# Access Compliance Report Public Rights-of-Way (Curb Ramps)

Main Street: ESPLANADE\_AVE Cross Street: SANTA\_CLARA\_AVE Location: SW

ADA ID: RPAT211026102342 Ramp Type: Type 1 - Perpendicular Diagonal Initial Pass/Fail: Fail Overall Compliance: No Severity Score: 2

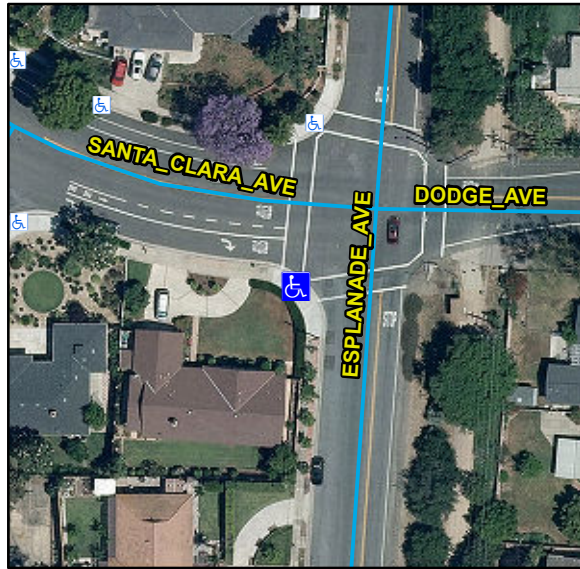
| Compliance | Description                           | Data | Compliance | Description                   | Data |
|------------|---------------------------------------|------|------------|-------------------------------|------|
| No         | Ramp Cross Slope (%)                  | 2.7  | N/A        | Flare Traversable LT          | N/A  |

Remove & Replace Curb Ramp With Two New Directional Ramps or Equivalent.

R304.2.2, R304.5.3, STD 1115
